Application for Plan Review
Fish Processing Warehouse and Fish Sales
450 Marine View Drive (proposed address)

Plan Review Application Number: PR-070121-1

RE: Completeness Letter
Design Review Application – Bott’s Marsh, LLC
2N-10W-02BB Tax Lot 400; and 2N-10W-02BC Tax Lot 4800

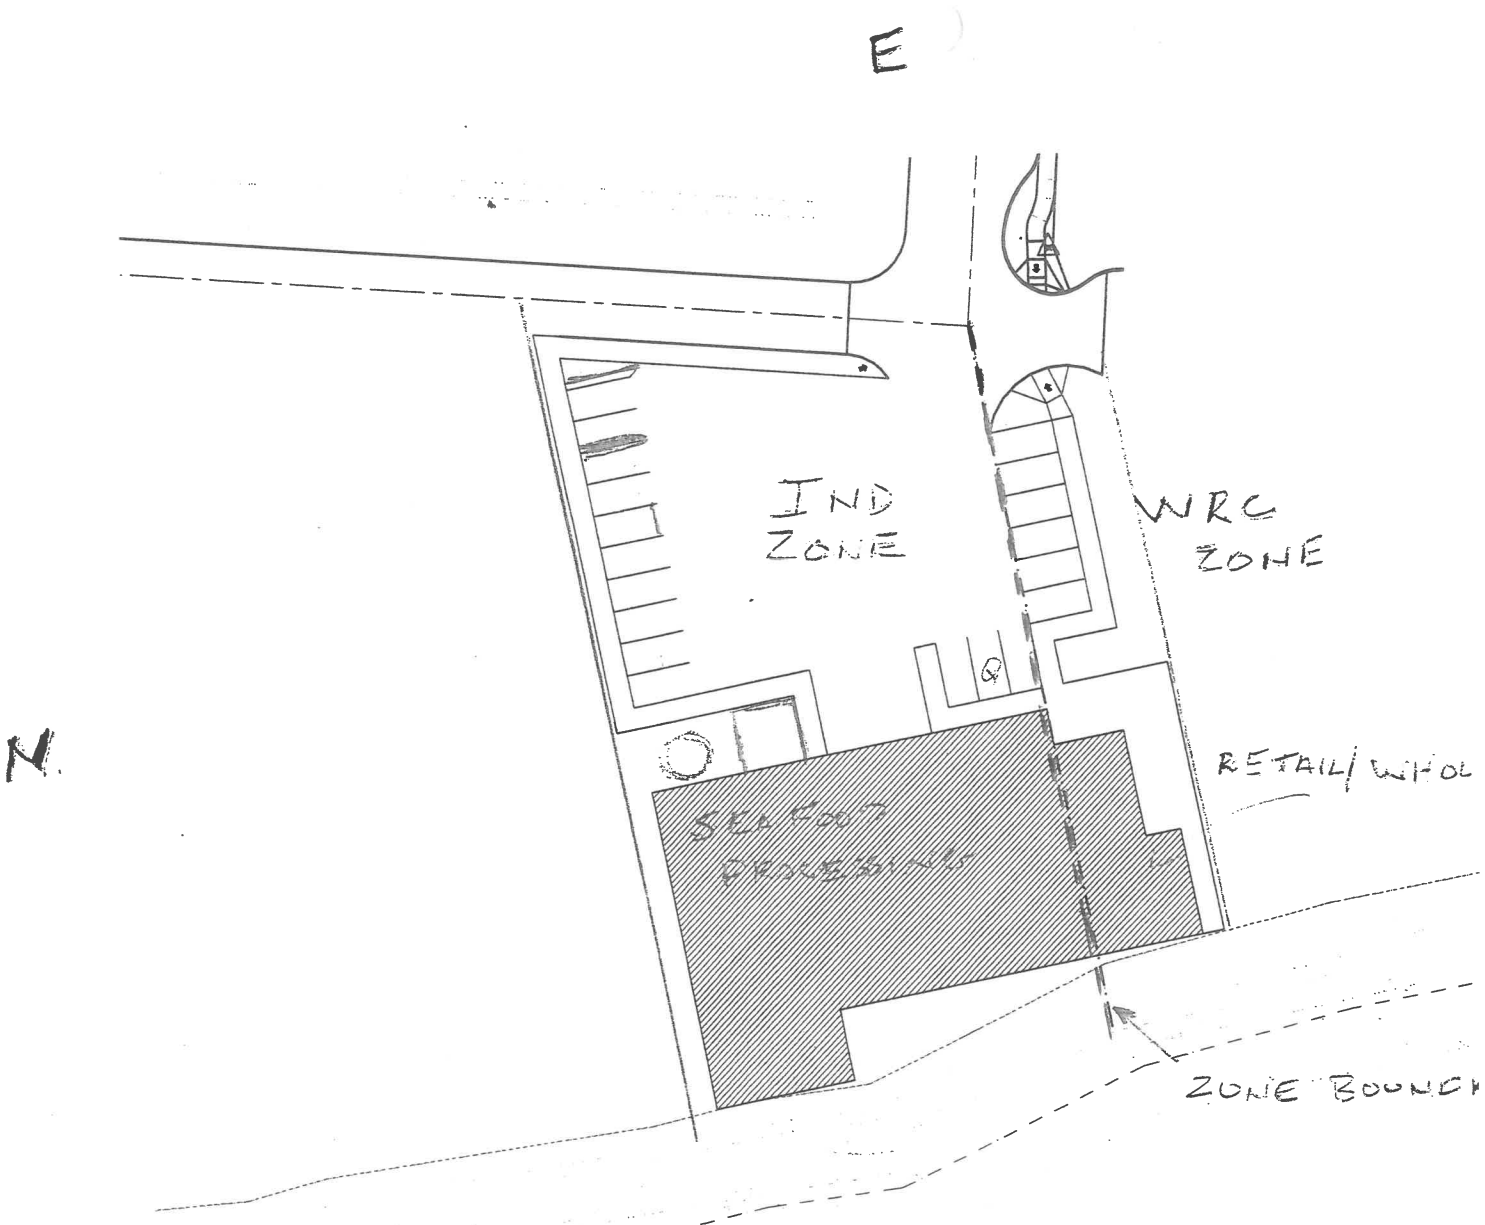
- The parking lot needs to meet ADA standards.

See EXBIBIT II – Site Plan

1 SITE PLAN
A1.02 1/16" = 1'-0"

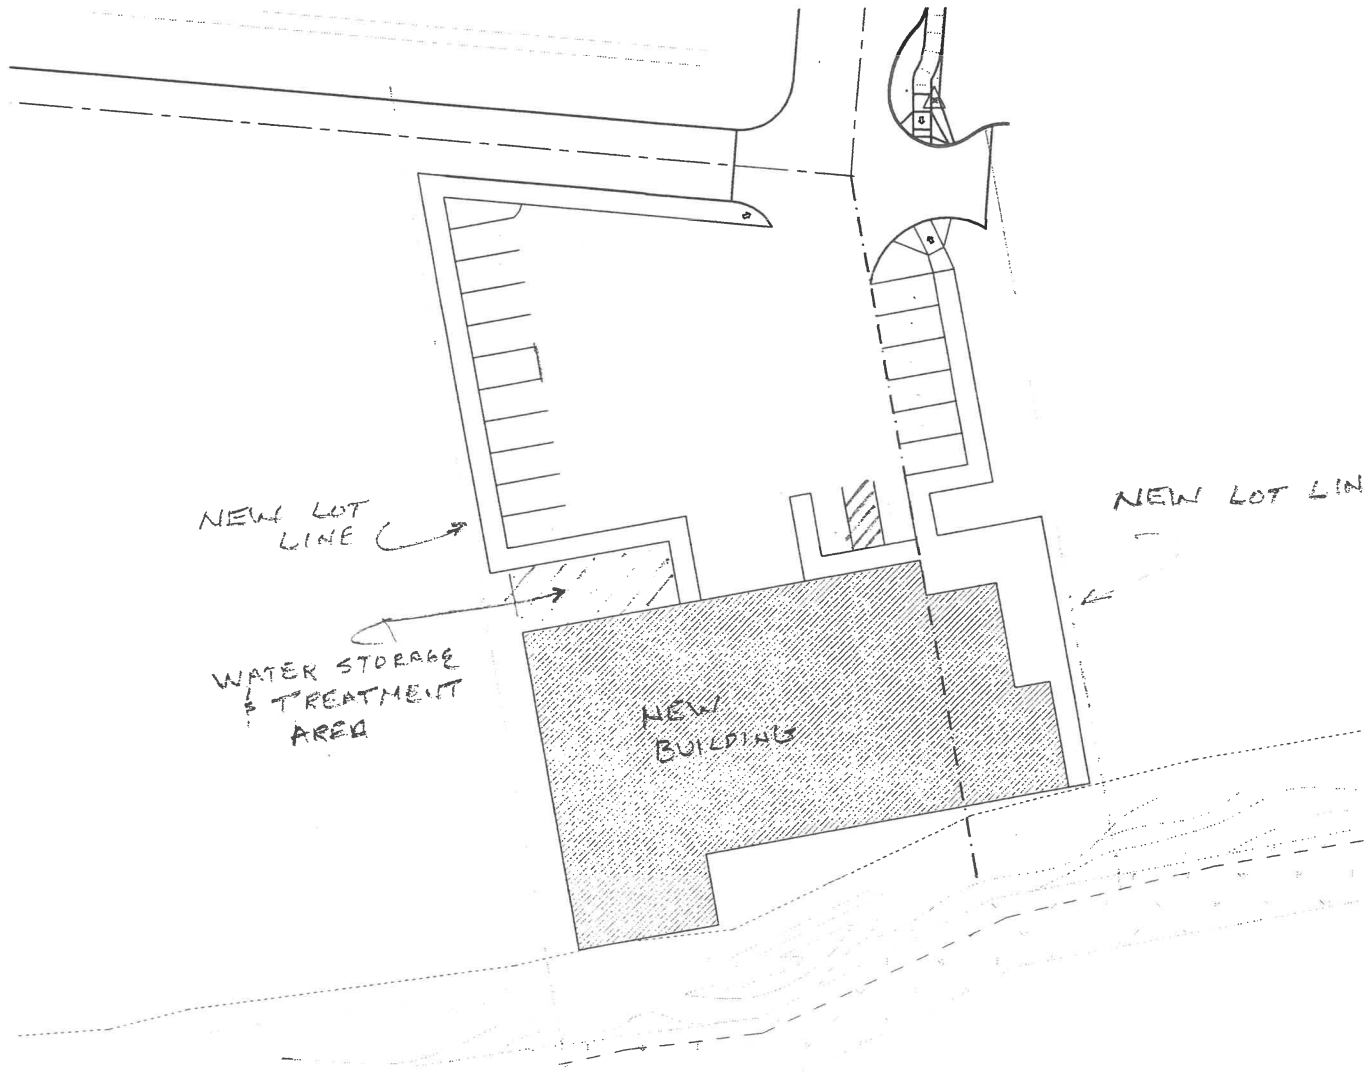
- Depict the storm drain line. Whose is it?
